**AGENDA**  
**PLANNING & ZONING COMMISSION SPECIAL MEETING**  
**TUESDAY, JULY 26, 2022 - 3:30 PM**  
**McAllen Development Center, 311 N. 15<sup>th</sup> Street, McAllen, Texas**  
**EXECUTIVE CONFERENCE ROOM, PLANNING DEPARTMENT**

**Memo**

**TO:** Planning and Zoning Commission  
**FROM:** Planning Staff  
**DATE:** July 11, 2022  
**SUBJECT:** **SITE PLAN APPROVAL FOR LOT 10, CITRUS GROVE PLAZA PHASE 1-A, LOT 10. 4129 EXPRESSWAY 83. (SPR2022-0036)**

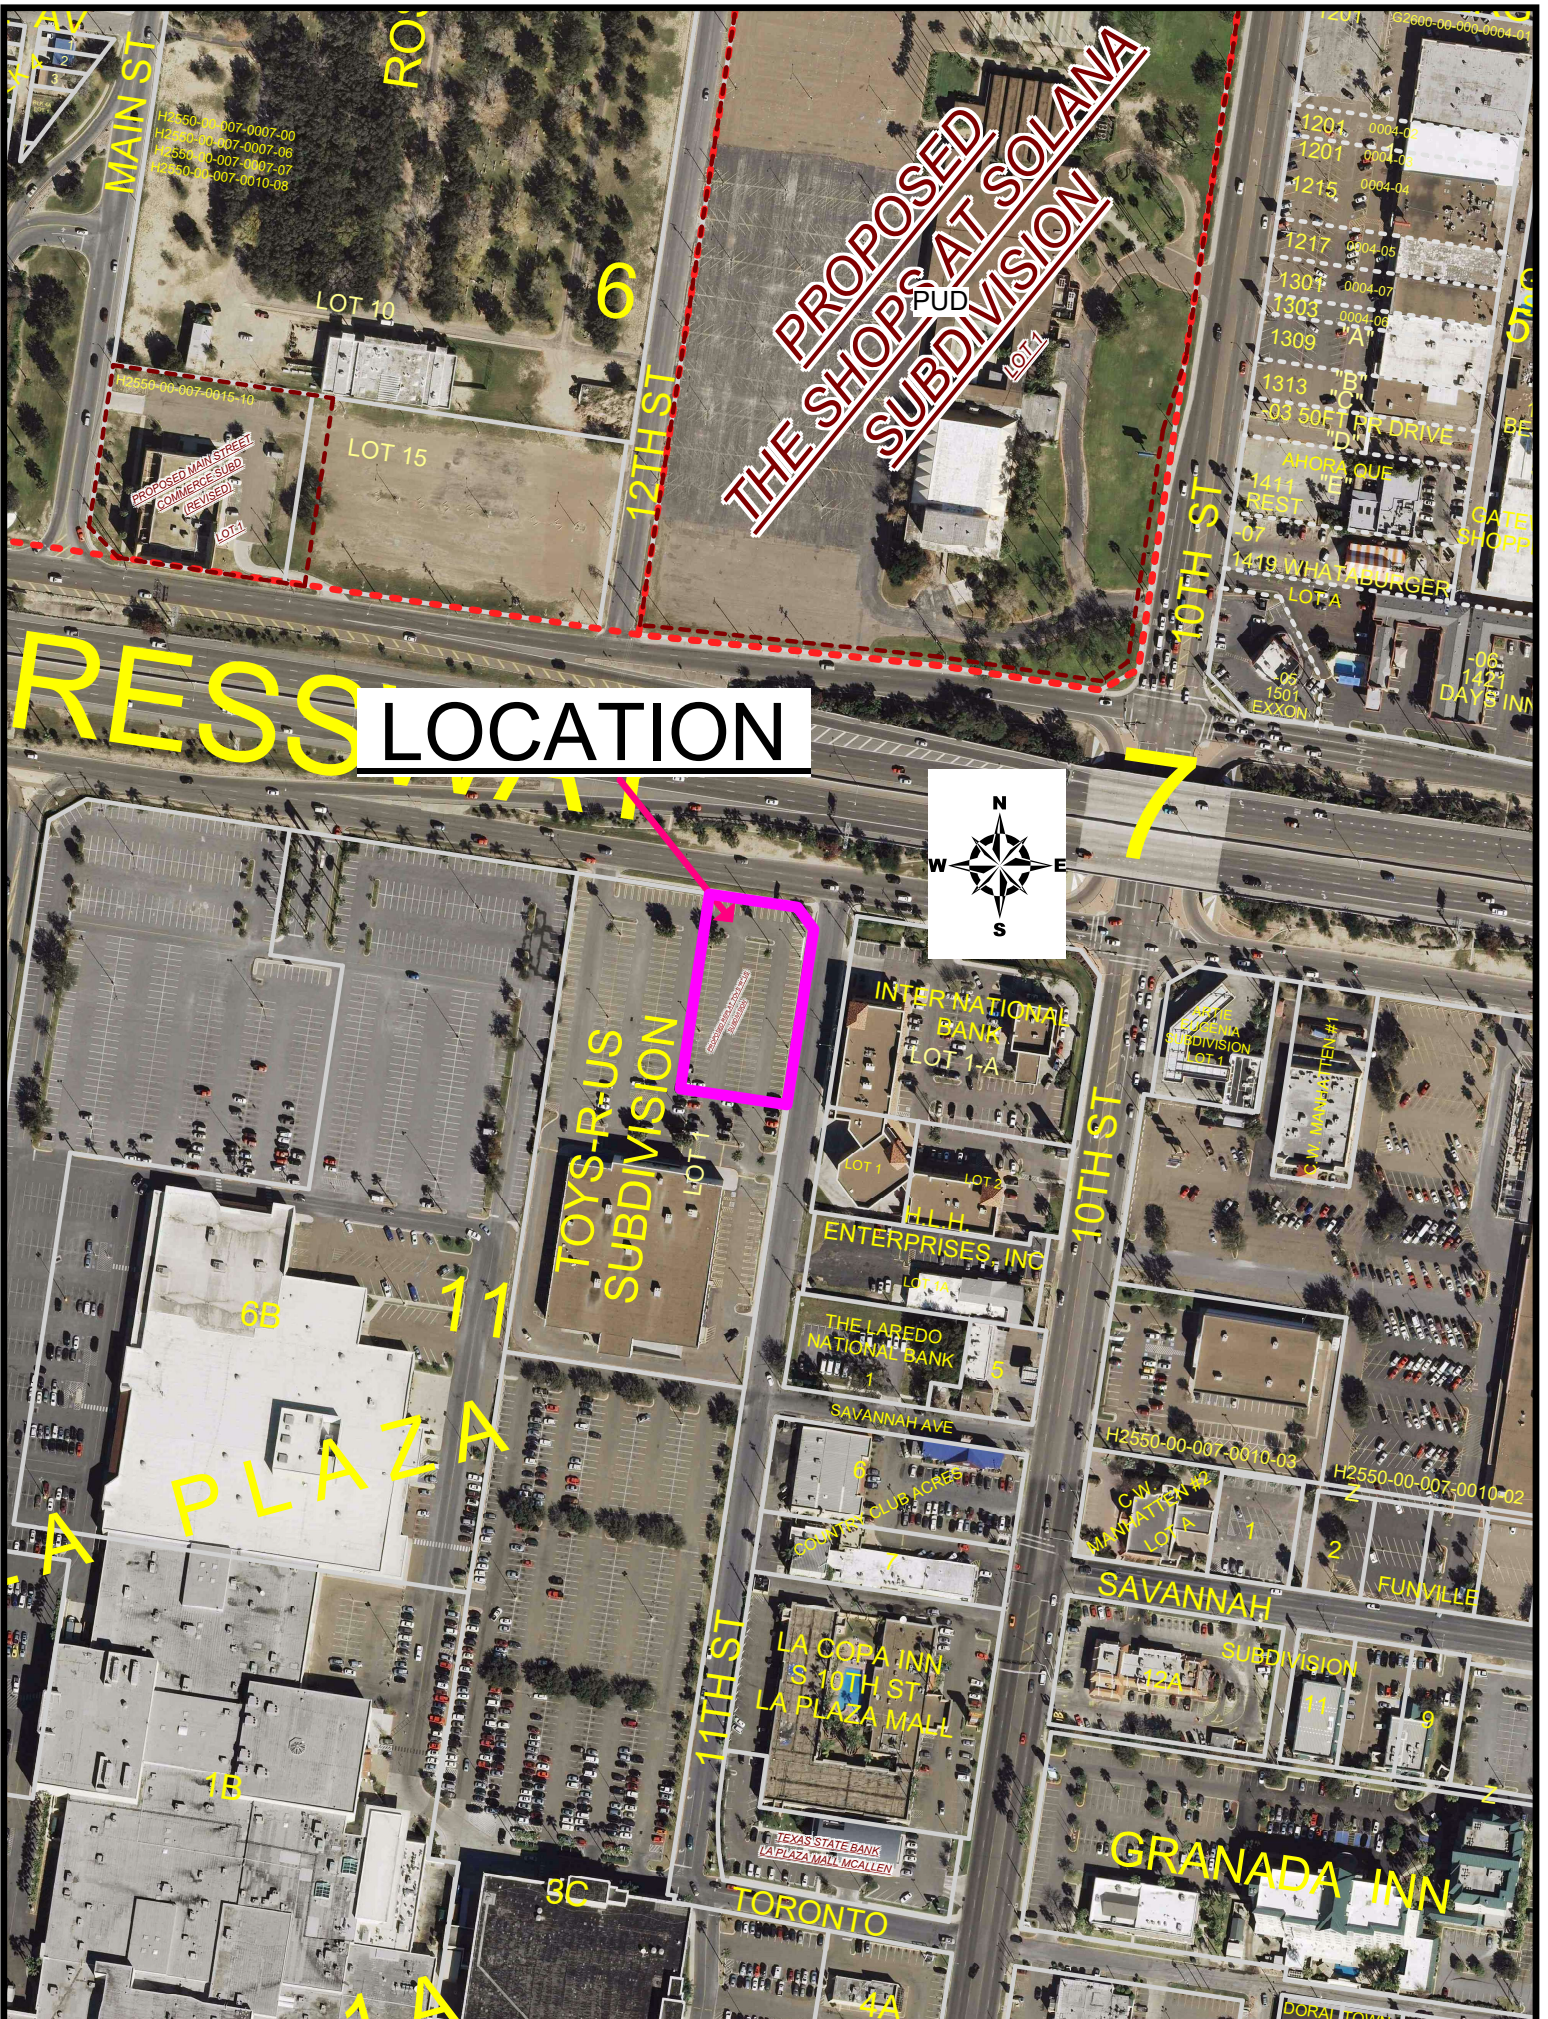
<b>SUBDIVISION NAME: TOYS "R" US</b>	
<b>REQUIREMENTS</b>	
<b>STREETS AND RIGHT-OF-WAYS</b>	
<p>U.S Expressway 83(Frontage Rd): Proposing 320 ft. of total ROW.                      Paving : By the State Curb &amp; gutter: By the State.                      *Thoroughfare Plan references 350 ft. of ROW, finalize prior to final.                      **Label centerline along U.S Expressway 83(Frontage Rd), prior to final.                      ***Label ROW dedications from centerline to new plat boundary, total, existing, etc., prior to final.                      ****Provide Document Numbers on plat for existing ROW dedication and Documents, prior to final.                      *****Finalize ROW requirements prior to final.                      *****Subdivision Ordinance: Section 134-105                      *****Monies must be escrowed if improvements are required prior to final                      *****COM Thoroughfare Plan</p>	Non-compliance

<p>South 11th Street: Dedication as needed for 30ft. from centerline for 60ft. total ROW.                      Paving 40 ft. Curb &amp; gutter: Both Sides.                      *Verify ROW dedications as they do not correspond with original plat, revise as applicable.                      **Label centerline along South 11th Street, prior to final.                      ***Label ROW dedications from centerline to new plat boundary, total, existing, etc., prior to final.                      ****Provide Document Numbers on plat for existing ROW dedication and Documents, prior to final.                      *****Finalize ROW requirements prior to final.                      *****Subdivision Ordinance: Section 134-105                      *****Monies must be escrowed if improvements are required prior to final                      *****COM Thoroughfare Plan</p>	Non-compliance
<p>Paving _____ Curb &amp; gutter _____                      **Subdivision Ordinance: Section 134-105                      **Monies must be escrowed if improvements are required prior to final                      **COM Thoroughfare Plan</p>	Applied

SETBACKS	
<p>* Front:75 Feet-U.S Expressway 83(Frontage Rd.) 30 Feet-S.11th Street **Revise note as shown above, prior to final. ***Proposing: 11th Street: 25 ft. or greater for approved site plan or easement. U.S Expressway 83 (Interstate 2): 70 ft. or greater for approved site plan or easement. *****Zoning Ordinance: Section 138-356</p>	Non-compliance
<p>* Rear: In accordance with Zoning Ordinance or greater for easements or approved site plan, whichever is greater applies. **Revise note as shown above, prior to final. ***Proposing: In accordance with the Zoning Ordinance or greater for easements. ****Zoning Ordinance: Section 138-356</p>	Non-compliance
<p>* Sides: In accordance with Zoning Ordinance or greater for easements or approved site plan, whichever is greater applies. **Revise note as shown above, prior to final. ***Proposing Side: In accordance with the Zoning Ordinance, or greater for easements. **Zoning Ordinance: Section 138-356</p>	Non-compliance

<p>*Site Plan Approval By The Planning and Zoning Commission Required Prior to Building Permit Issuance.                  **Note wording must be finalized prior to final and a separate note number will be required.                  ** *Site plan must be approved by the Planning and Development Departments prior to building permit issuance.                  * Common Areas, any private streets/drives, gate areas, etc. must be maintained by the lot owners and not the City of McAllen.                  * Common Areas for commercial developments provide for common parking, access, setbacks, landscaping, etc.                  * Developer/Homeowner's Association/Owner, their successors and assignees, and not the City of McAllen shall be responsible for compliance of installation and maintenance and other requirements per Section 134-168 of the Subdivision Ordinance, including but not limited to common areas and its private streets.                  **Section 110-72 applies if private subdivision is proposed.                  **Landscaping Ordinance: Section 110-72                  **Subdivision Ordinance: Section 134-168                  * Homeowner's Association Covenants must be recorded and submitted with document number on the plat, prior to recording.                  **Section 110-72 applies if private subdivision is proposed.                  **Landscaping Ordinance: Section 110-72                  **Subdivision Ordinance: Section 134-168</p>	Non-compliance

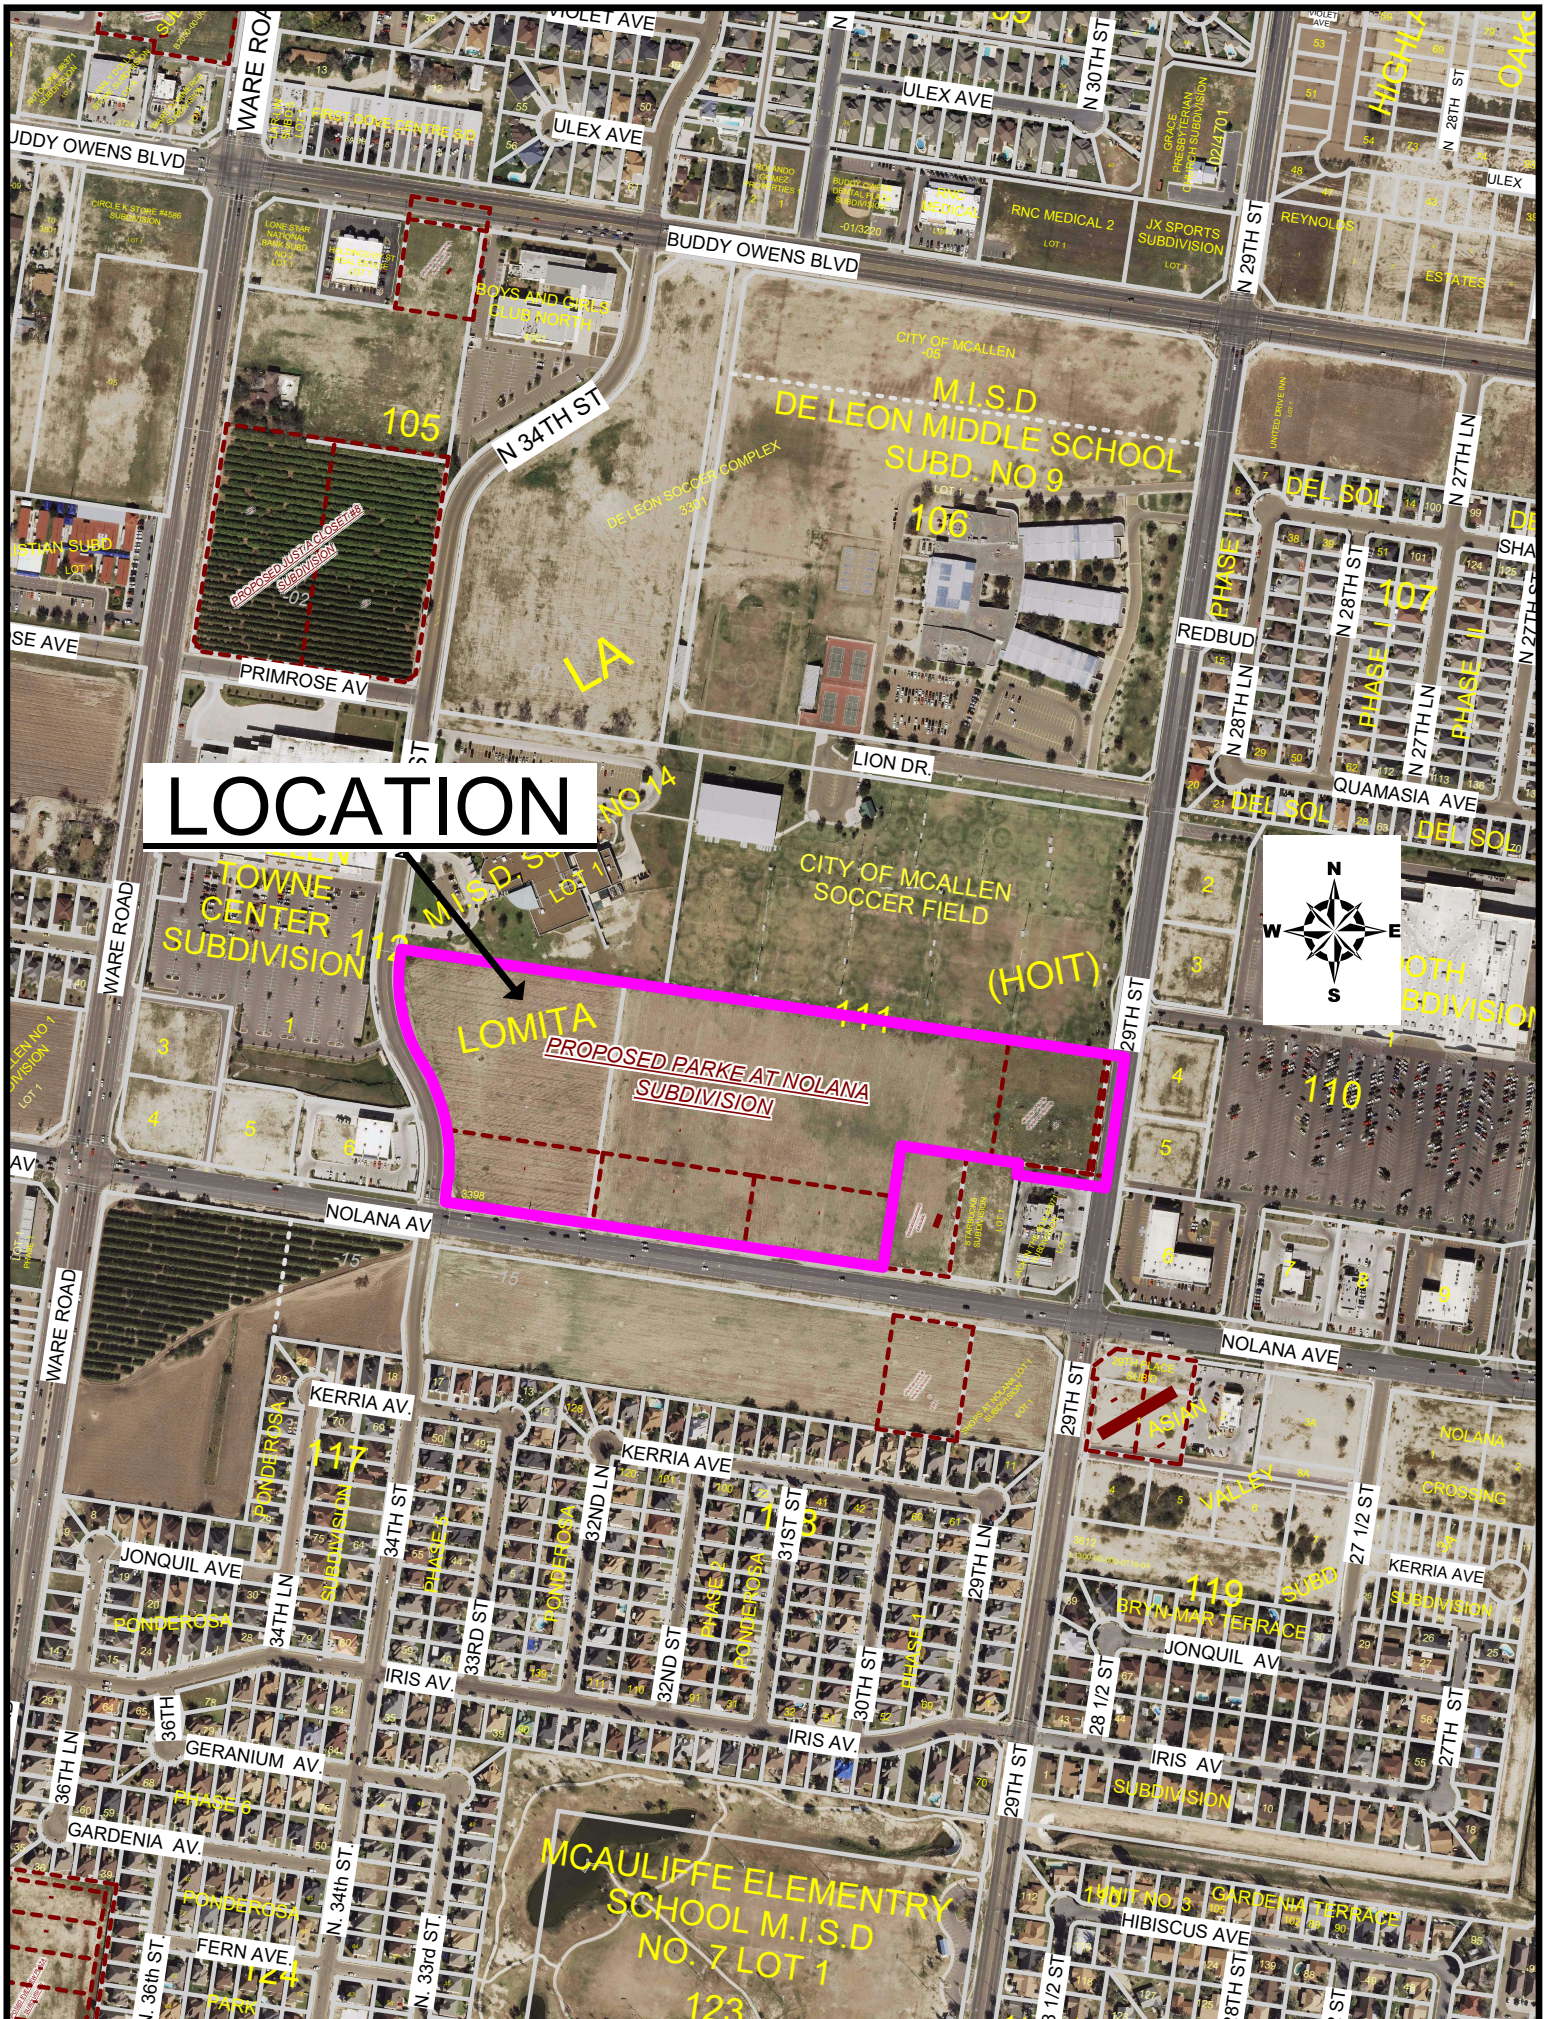
<p>* 600 ft. Maximum Cul-de-Sac                      **Subdivision Ordinance: Section 134-105</p>	NA
<b>ALLEYS</b>	
<p>ROW: 20 ft. Paving: 16 ft.                      *Alley/service drive easement required for commercial properties                      **Subdivision Ordinance: Section 134-106</p>	Non-compliance

SETBACKS	
<p>* Front/Nolana Avenue: Proposing 60 ft. or in line with existing structures, approved site plan, or greater for easements, whichever is greater applies.                      **Plat note #3 must be revised as shown above prior to final.                      **Zoning Ordinance: Section 138-356</p>	Non-compliance
<p>* Rear: In accordance with the zoning ordinance or approved site plan, or greater for easements, whichever is great applies.                      **Please revised plat note #3 as shown above prior to final.                      **5 ft. setback is required from any proposed service drives.                      **Zoning Ordinance: Section 138-356</p>	Non-compliance
<p>* Sides: In accordance with the zoning ordinance, or approved site plan, or greater for easements, whichever is great applies..                      **Please revise plat note #3 as shown above prior to final.                      **Zoning Ordinance: Section 138-356</p>	Non-compliance
